Bulletin: TAIB-0831

Subject: Loose ECA Connectors in UltraShift® *PLUS* Models

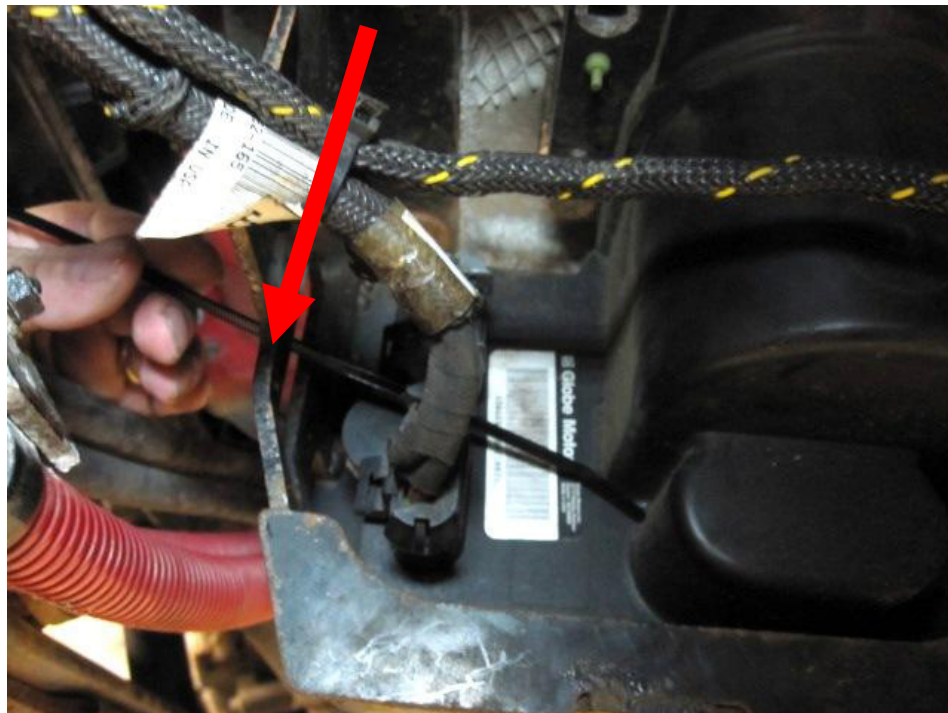
One or both of the ECA connectors (3-way and/or 8-way) may be loose; causing ECA related faults to occur:

- ECA 3-way and 8-way connectors may not fully seat and latch.
- Transmission harness routing may lead to excessive side loading of the ECA connectors.

The current style ECA shield has been revised to improve harness routing and eliminate side loading of the ECA connectors on transmissions built after December 22, 2011.

Tie-wrap the ECA 3-way and 8-way connectors with zip ties on units that have the old style ECA shield used before December 22, 2011.

1. Ensure both the 3-way and 8-way ECA connectors are properly seated.
2. Insert zip tie around connector.

3. Loop zip tie around connector.

4. Slide the loop around

5. Tightly secure the zip tie around the connector, ensuring locking mechanism of zip tie is on top of the locking connector tab.

Important: Ensure locking mechanism of zip tie is on top of the locking connector tab. Cut excess zip tie banding and discard.
